Before a Board of Inquiry
MacKays to Peka Peka Expressway Proposal

Statement of rebuttal evidence of **Noel Nancekivell** (Design – MacKays to Peka Peka Expressway) for the NZ Transport Agency

Dated: 25 October 2012

STATEMENT OF REBUTTAL EVIDENCE OF NOEL NANCEKIVELL FOR THE NZ TRANSPORT AGENCY

**ANNEXURE C – PLAN SHOWING THE ALTERNATIVE ACCESS
TO NGA MANU**

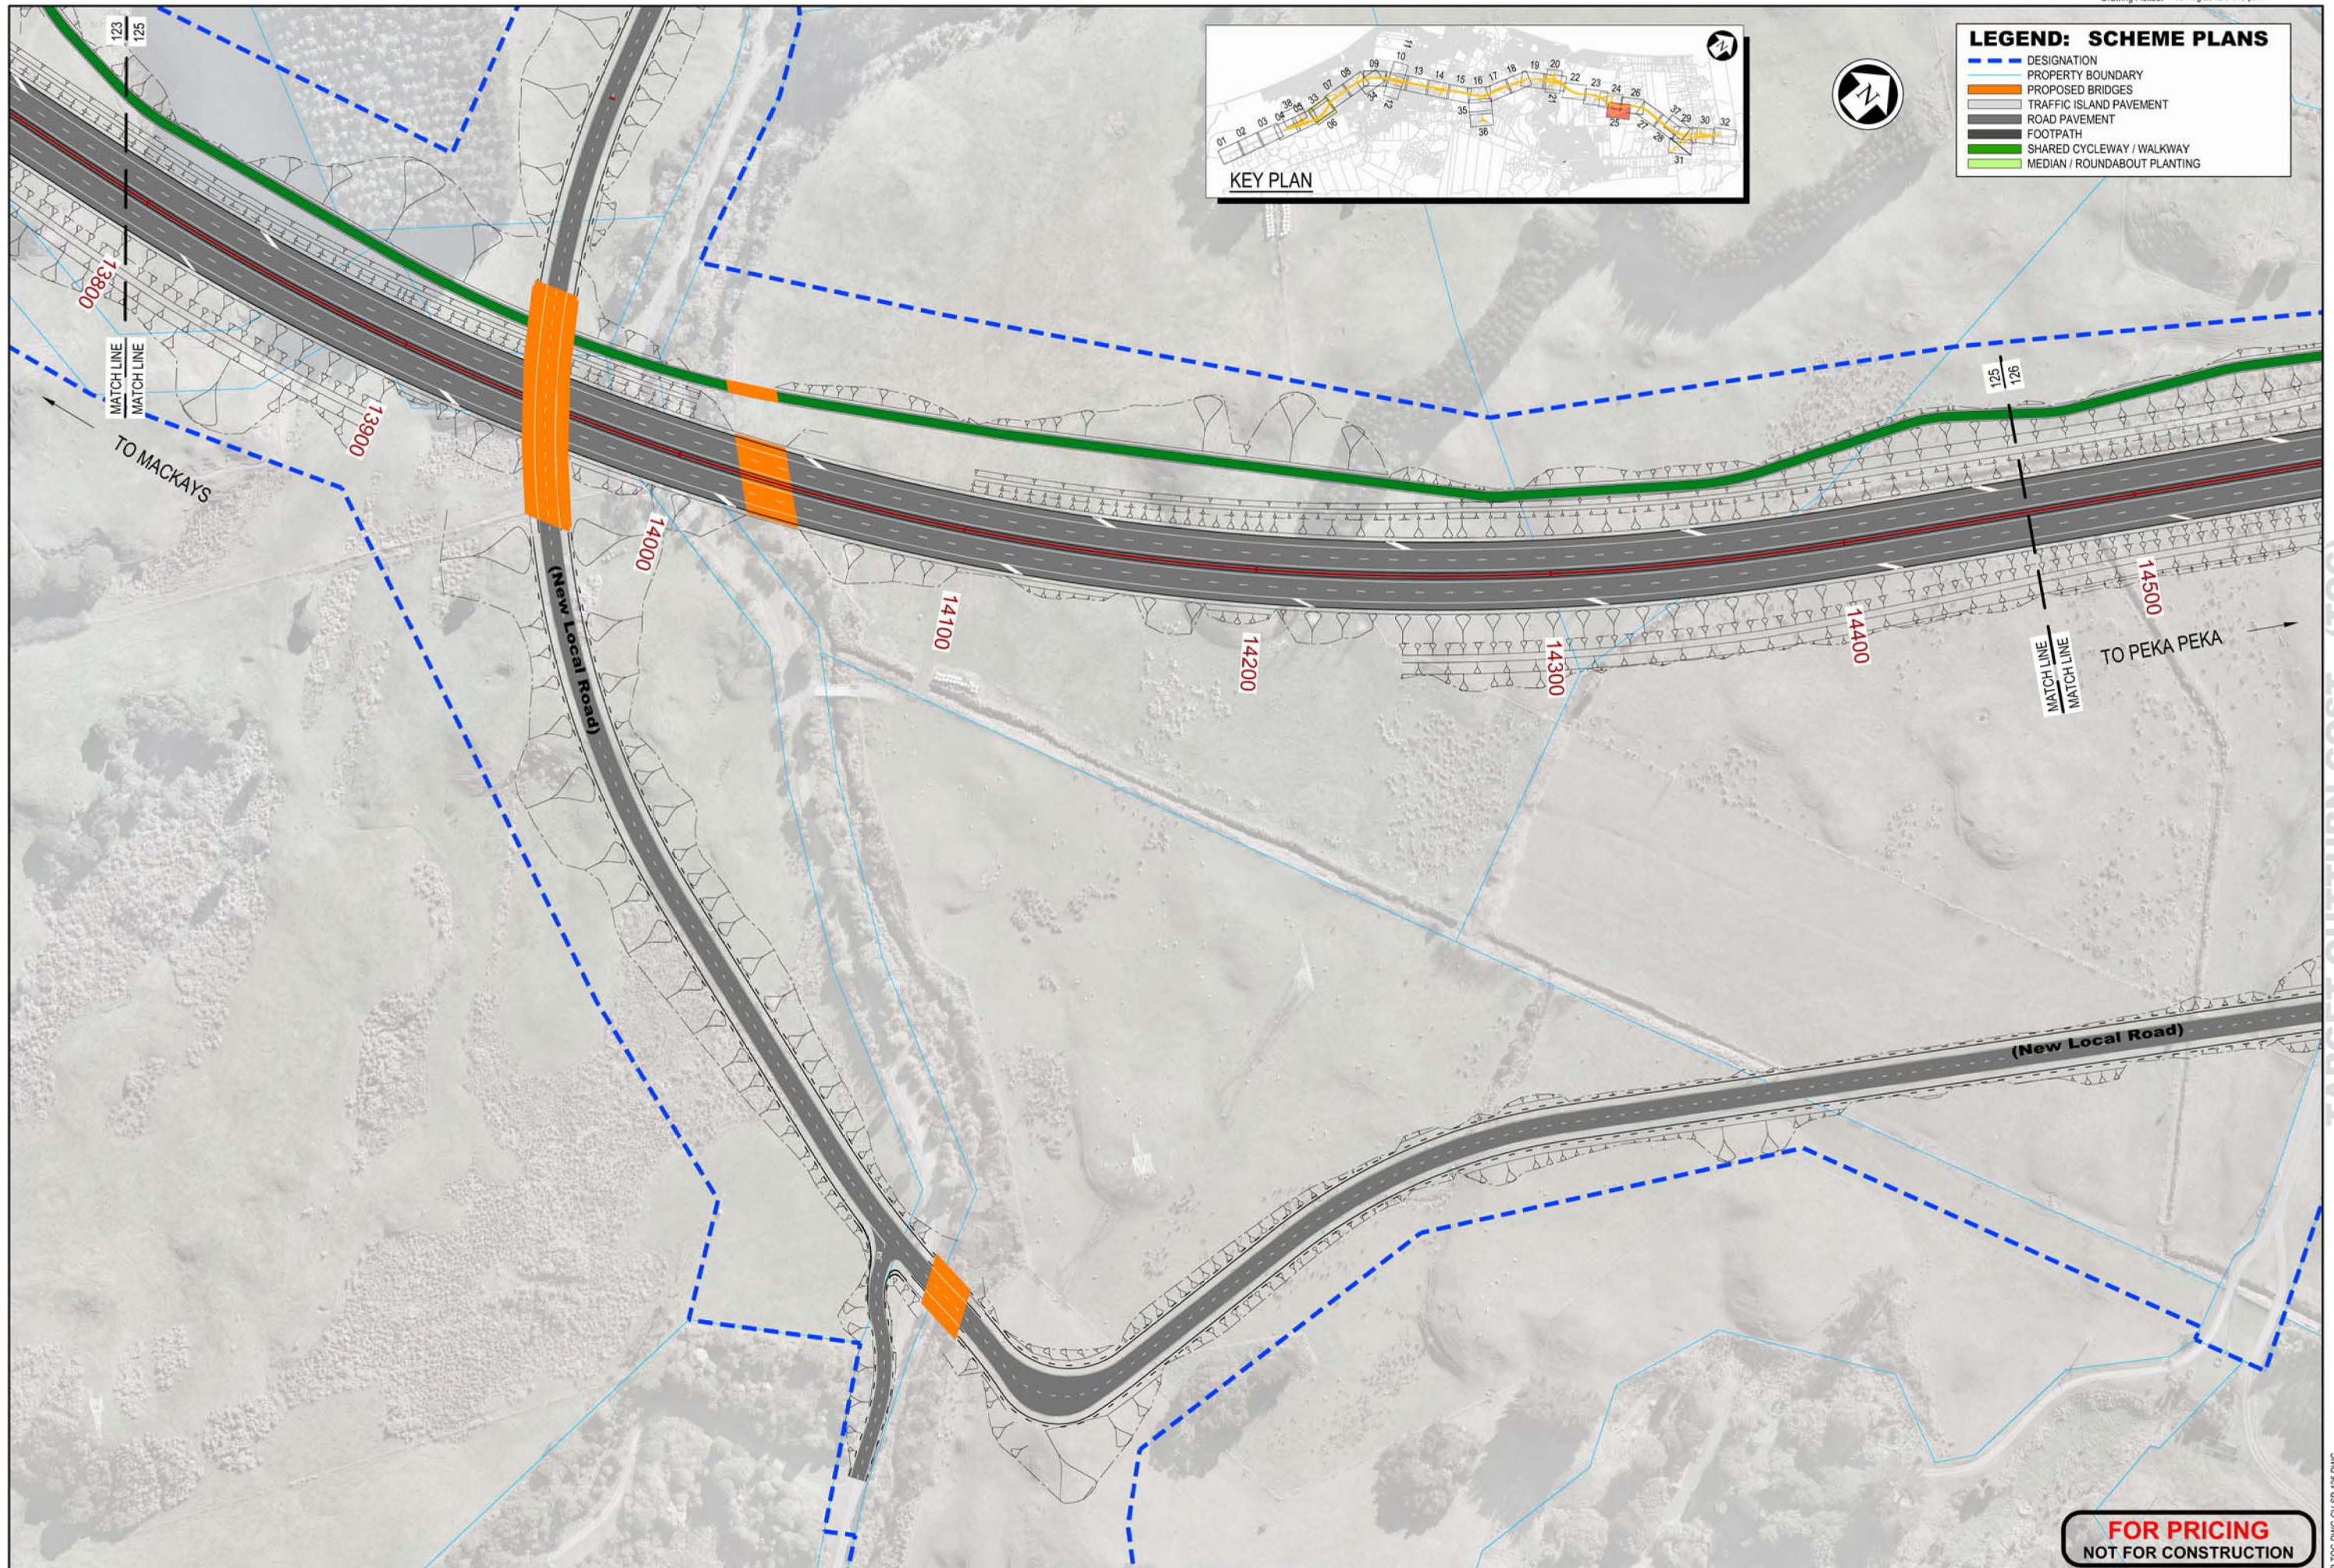
- 18 At paragraphs 8.1-8.5 of his evidence, Mr Munro discusses the access to Nga Manu, and in response Ms Thomson proposes a condition, at paragraph 9.3 relating to the connection with Nga Manu. As noted at paragraph 120 of my EIC, concepts have been developed for alternative access to Nga Manu and will be included in the Project. These concepts are attached as **Annexure C**.
- 19 I understand NZTA has come to an agreement with KCDC that the proposed access road would be built to a standard that is commensurate with local arterial roads so that this road can function as an east-west local link road in future. As part of that agreement, the road would only be built to a higher standard than needed to provide access to the Nga Manu Nature reserve and Smithfield Road if funding is provided by KCDC for the difference in costs.

WAIKANAË-ON-ONE CONCEPT #2
 Te Moana Rd. Interchange - Kapiti Expressway
..TO REDUCE INTERCHANGE FOOTPRINT
 July 2011 Design: DR Drawn: SB

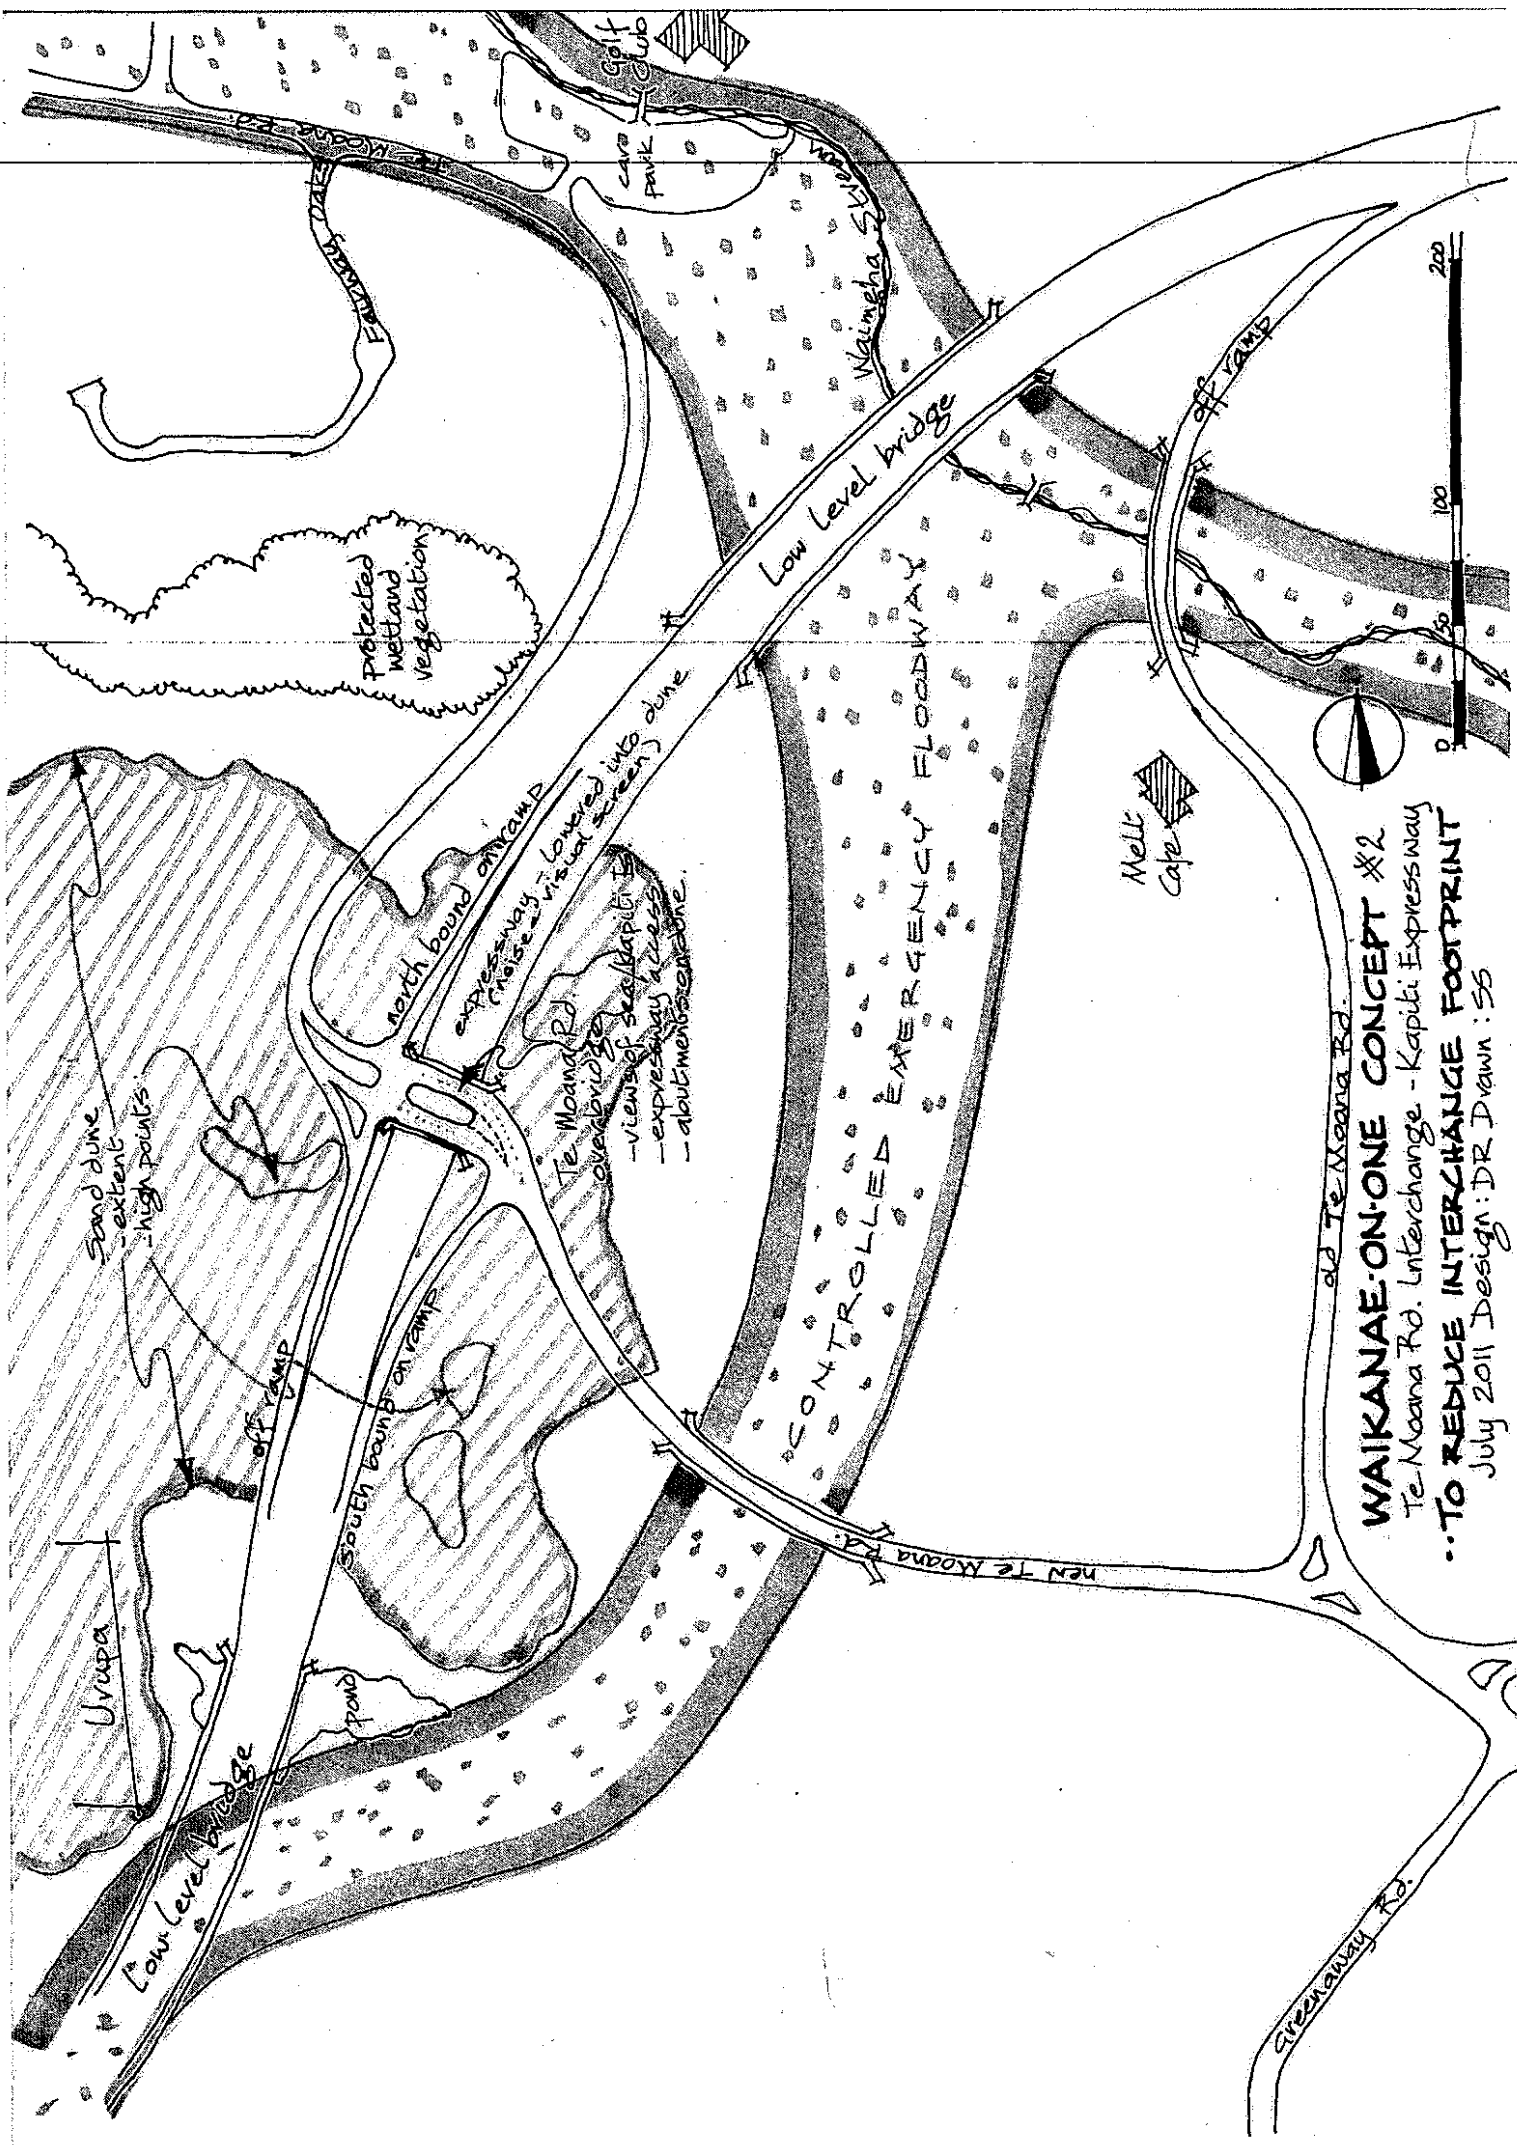
We have also received a further design option from you on 16th July. This is a further refinement of the previous options provided and most of the comments above apply to this concept as well. This option does reduce the number of houses required and does take the interchange away from the Te Moana Road.

However, there are a number of issues that make this option less desirable as listed below:

- Creates an 'island' of properties on Te Moana Road
- Requires full purchase of multiple owned Māori Land
- Makes future connections north of Te Moana Road to Maypole Property more difficult
- Contains more structure than Alliance design, 400m against 220m increasing the cost significantly
- Will require large retaining walls to construct the interchange
